STAFF RECOMMENDATION
916 Montrose Avenue
July 20, 2016

Metropolitan Historic Zoning Commission
Sunnyside in Sevier Park
3000 Granny White Pike
Nashville, Tennessee 37204
Telephone: (615) 862-7970
Fax: (615) 862-7974

Application: New construction-infill and outbuilding; Demolition of non-contributing building

Description of Project: New construction of a two-family residence on the site of a non-contributing building, and a new garage outbuilding at the rear of the lot.

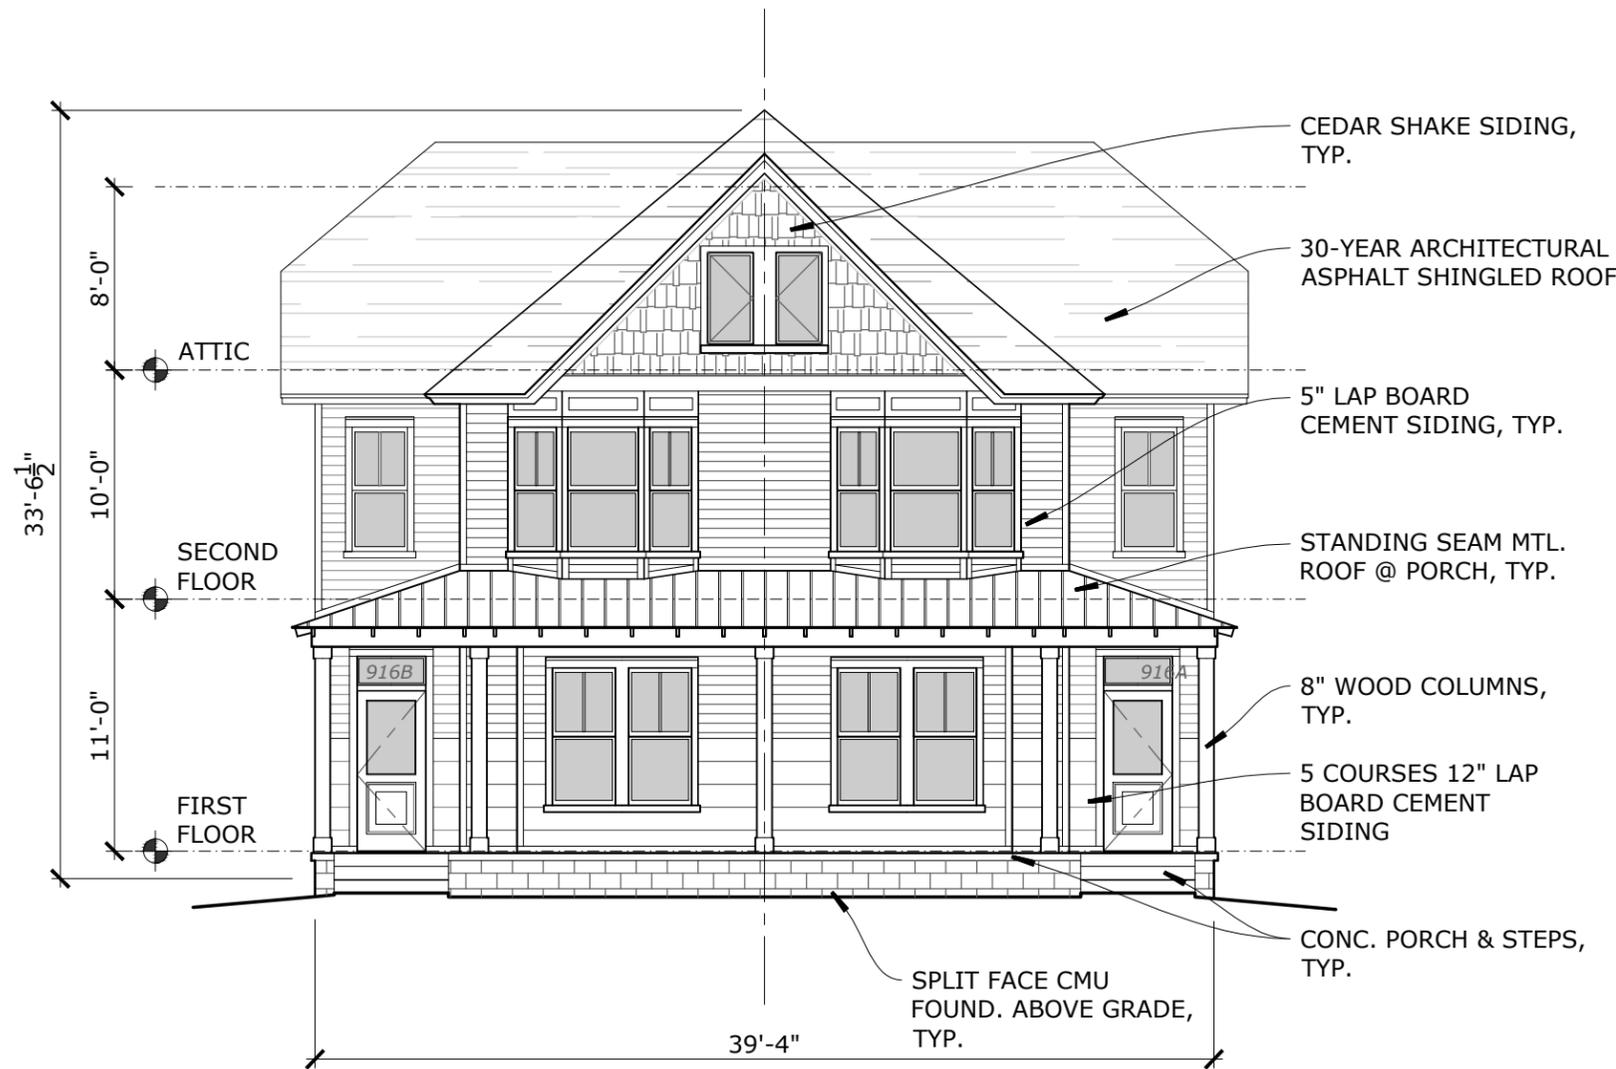
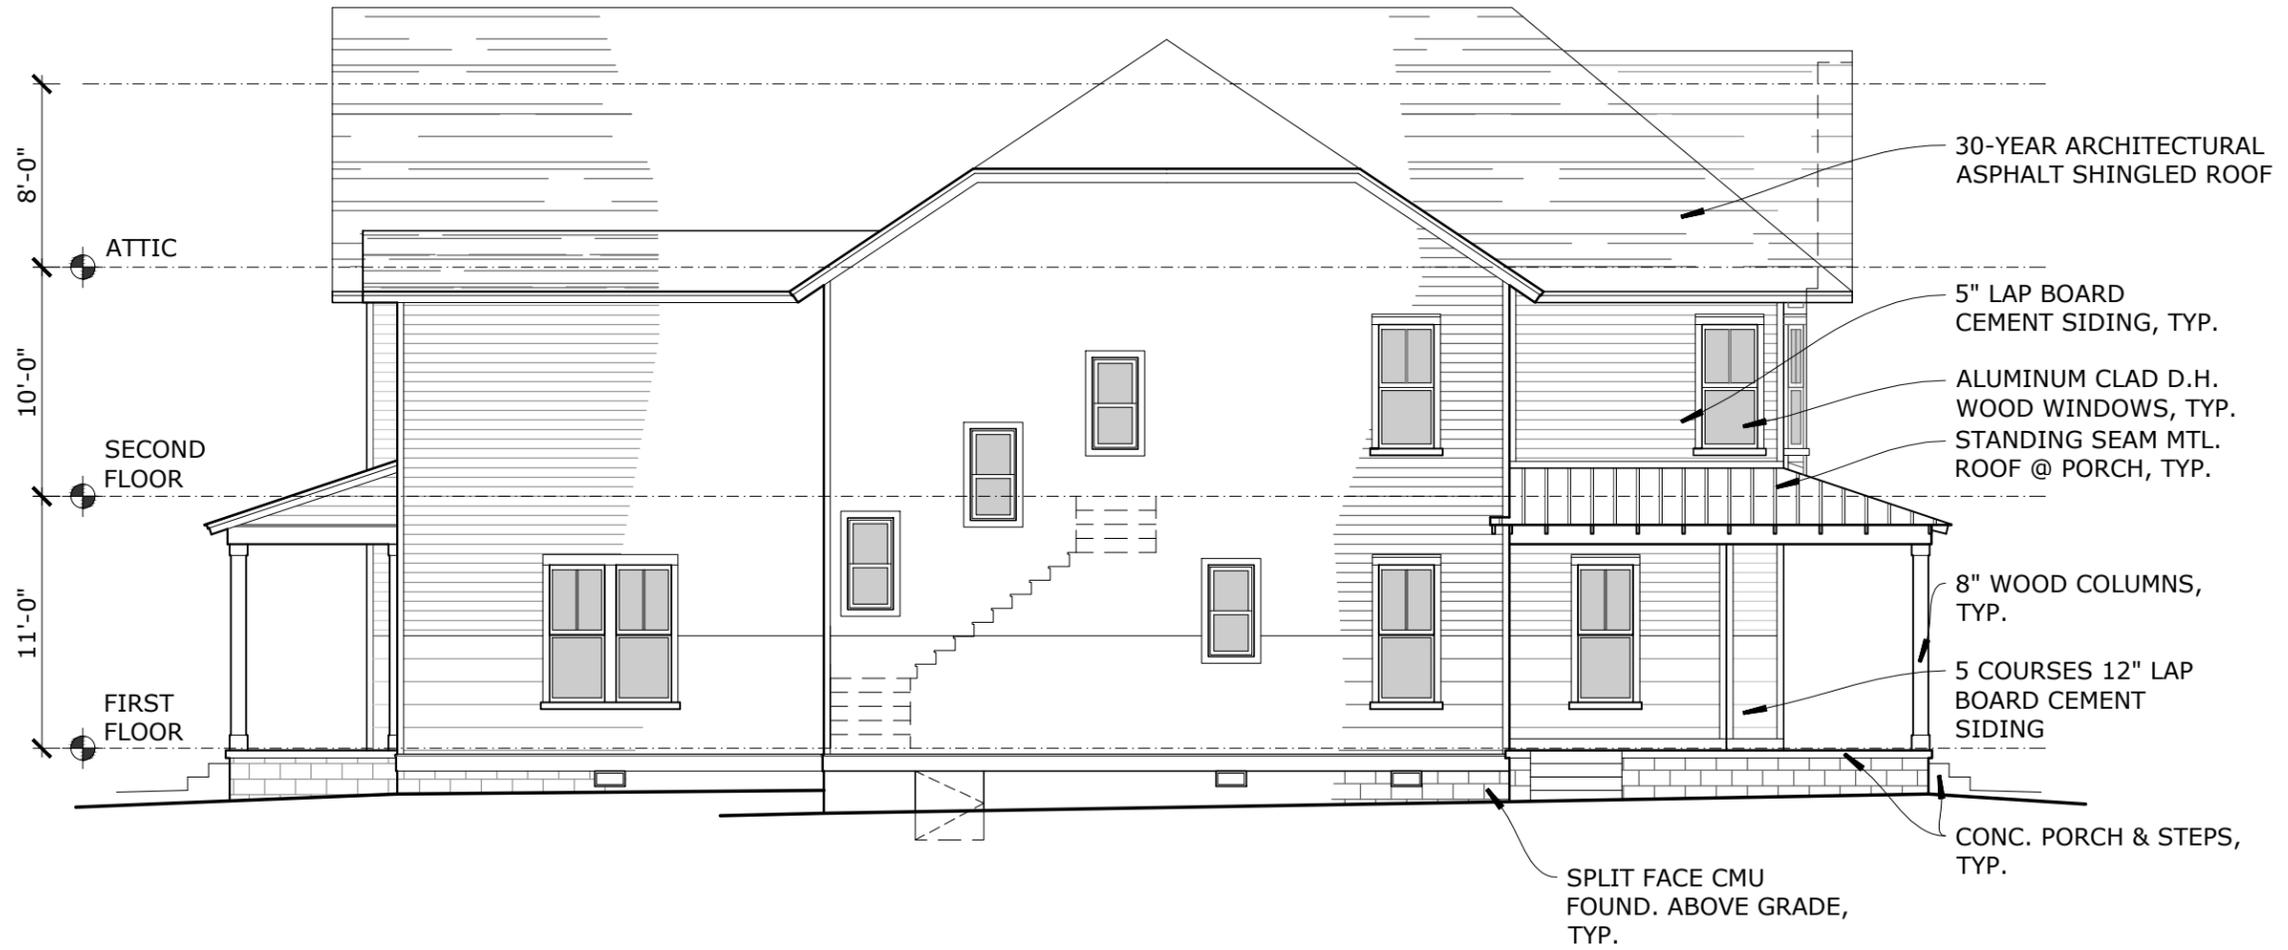
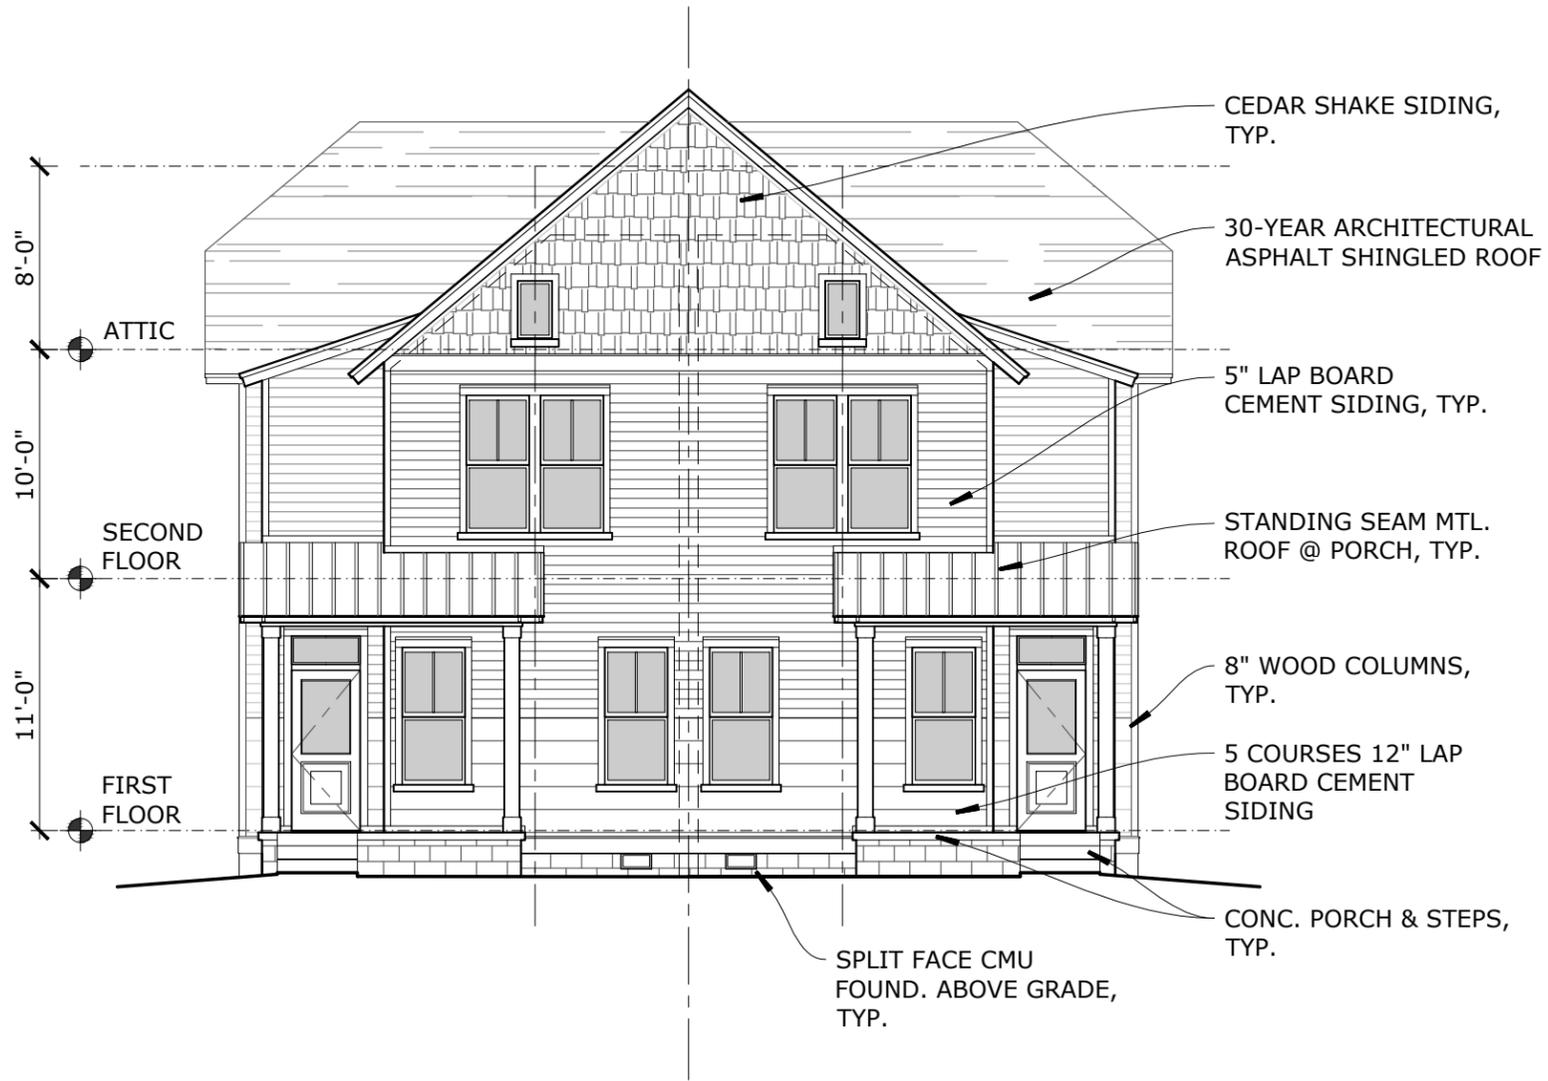
Staff's review is that the height of thirty-three feet, six inches (33' 6") is compatible with contributing historic buildings on this block, but that the building is too wide at thirty-nine feet, four inches (39' 4") at that height. The tallest buildings nearby are approximately thirty-two feet (32') wide. The widest buildings are up to forty feet (40') but they are one or one-and-a-half stories in height. The applicant has had this same design and similar massing approved by the Commission previously, but in a different neighborhood with its own context. Staff's recommendation is that the proposed infill has a maximum width of thirty-six feet (36'). With this condition, the infill will be compatible in massing with the context and will meet sections II.A.1.A and B for height and scale.

Proportion and Rhythm of Openings: The windows are generally twice as tall as they are wide, meeting the historic proportions of openings. The largest expanse of wall space without a window or door opening is on the second story of the left side, where there is seventeen feet (17') on the second story; as this is at the rear, staff finds it to be acceptable. Paired windows have four to six inch (4" to 6") mullions between them, as has been required in the past. Staff finds the project's proportion and rhythm of openings to meet Section III.G.

1. The building's width is reduced from thirty-nine feet, four inches (39' 4") to thirty-six feet (36');
2. The front setback matches the contributing structure at 920 Montrose, to be verified on a revised site plan;
3. The finished floor height shall be consistent with the finished floor heights of the adjacent historic houses, to be verified by MHZC staff in the field;

GARAGE PLAN & ELEVATIONS

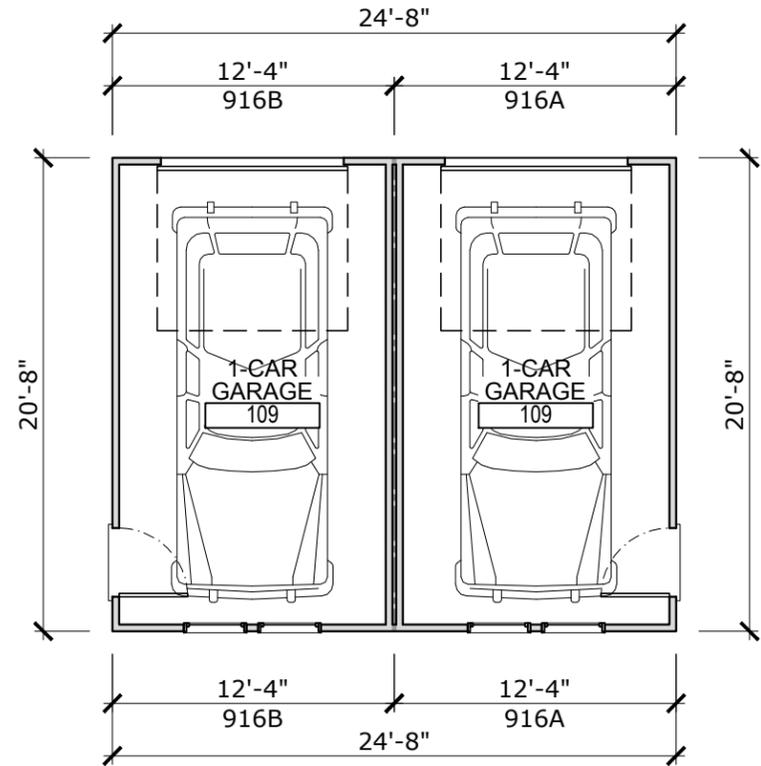
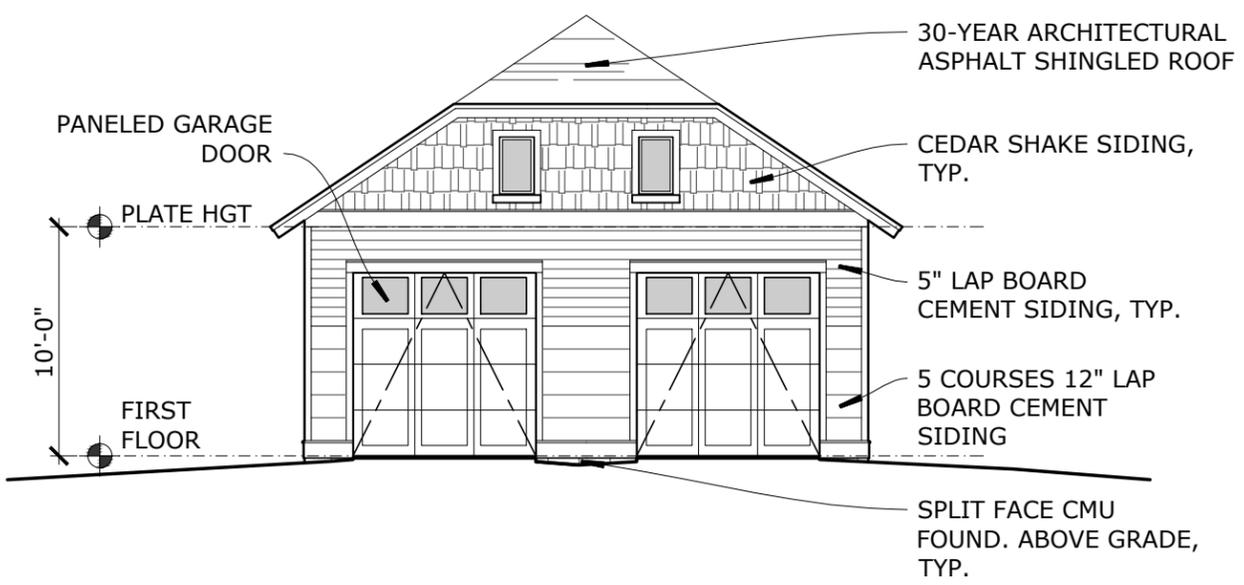
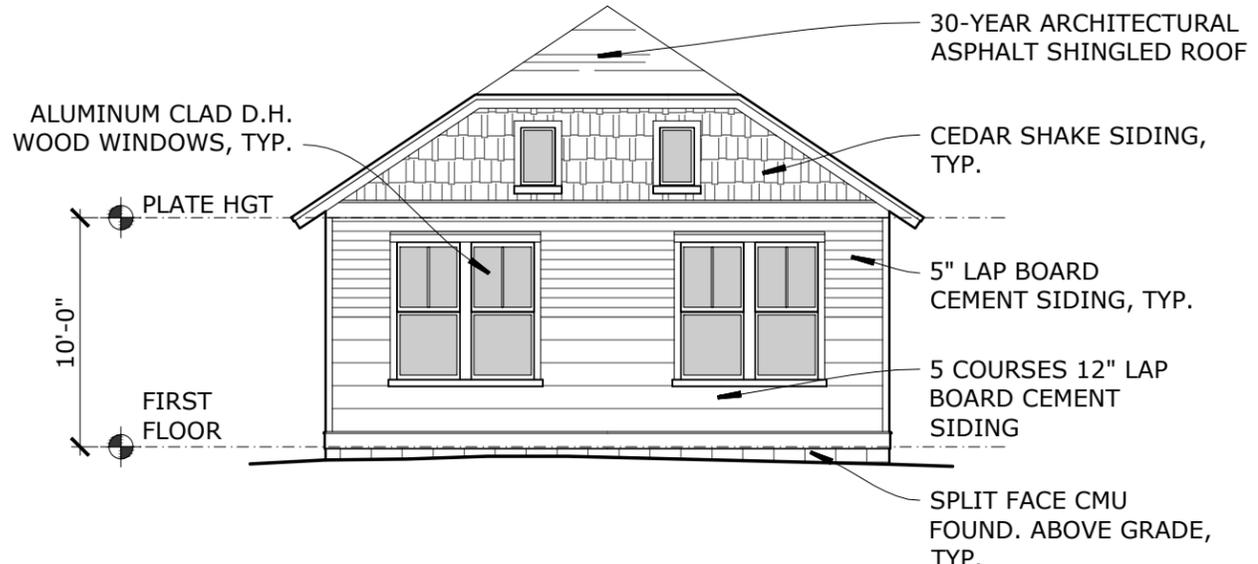
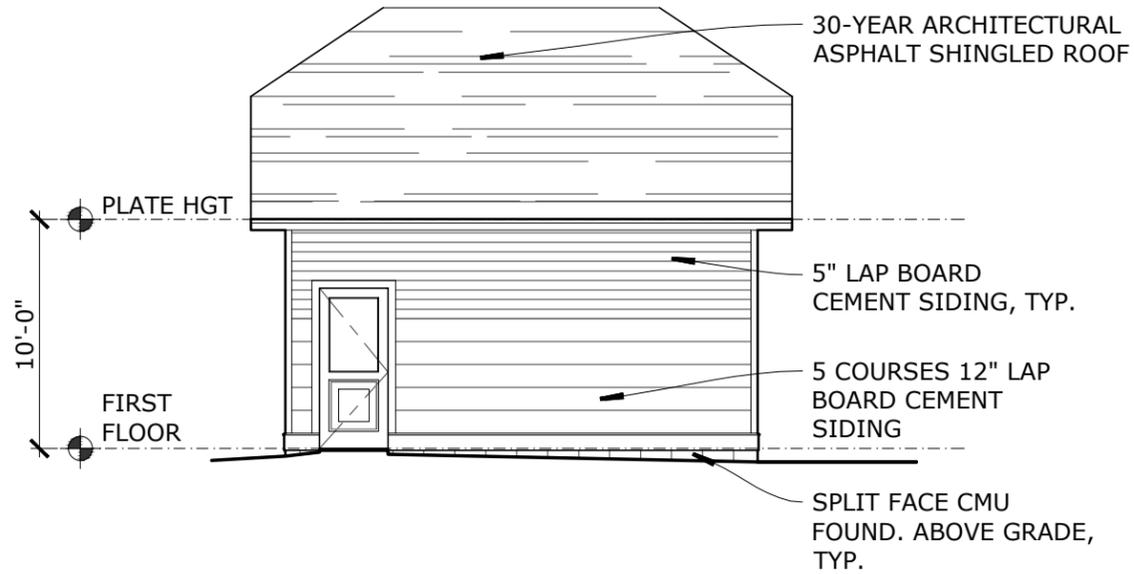
Proposed	Color/Texture	Approved Previously or Typical of Neighborhood
Foundation	Concrete slab	n/a	X
Cladding	Cement-fiber	n/a	X
Secondary cladding	Cedar shakes	Natural	X
Roofing	Asphalt shingle	Color not indicated	X
Trim	Not indicated	n/a	X
Chimney	None	n/a	X
Porch floor	None	n/a	X
Porch Posts	none	n/a	X
Porch Railing	none	n/a	X
Doors	Not specified		
Vehicle door	Not specified

Proposed Element	Proposed Form	Typical of district?
Primary massing	clipped	X
Primary roof slope	6/12	X
Dormer	none	X
Skylights	n/a	n/a
Solar Panels	n/a	n/a
Chimney	none	n/a

Finding the proposal to be similar to the immediate historic context, staff finds the project meets section III.H. of the design guidelines.

MONTROSE AVENUE ELEVATIONS

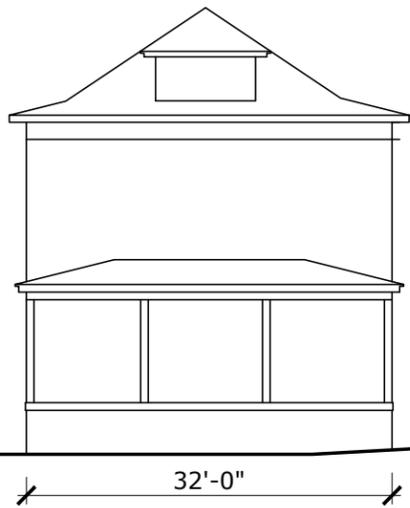
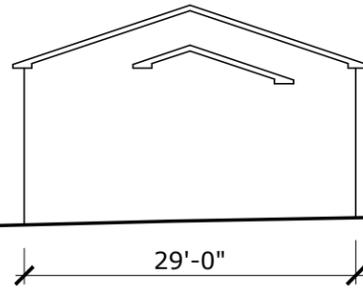
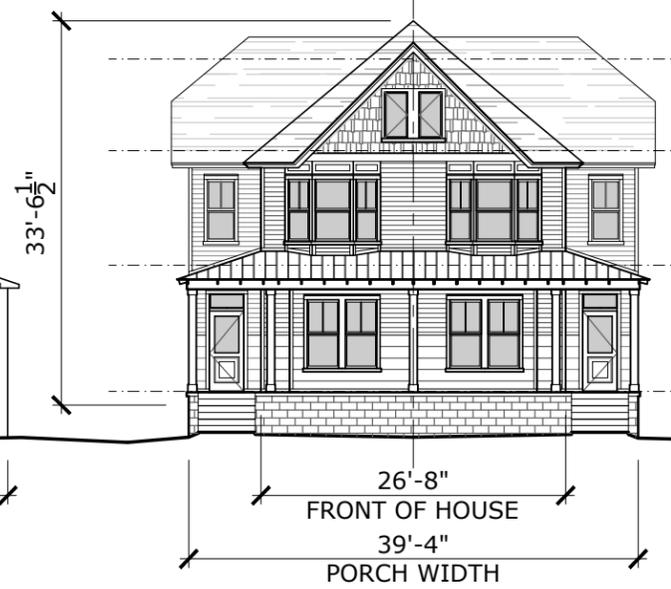
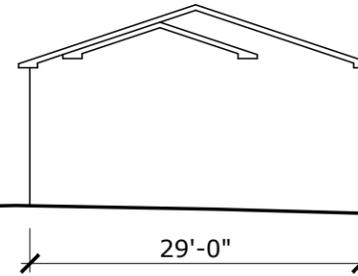
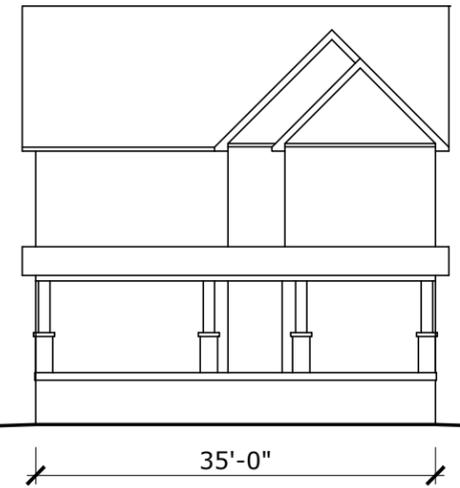
Staff measured the setback of the nearest contributing building at 920 Montrose to be approximately thirty-two feet (32') from the front property line to its porch. Staff recommends the front porch wall of this infill match that of 920 Montrose, with a site plan submitted showing the setback of the adjacent buildings on either side. With this condition, the application will meet section III.A.1.C for setbacks.
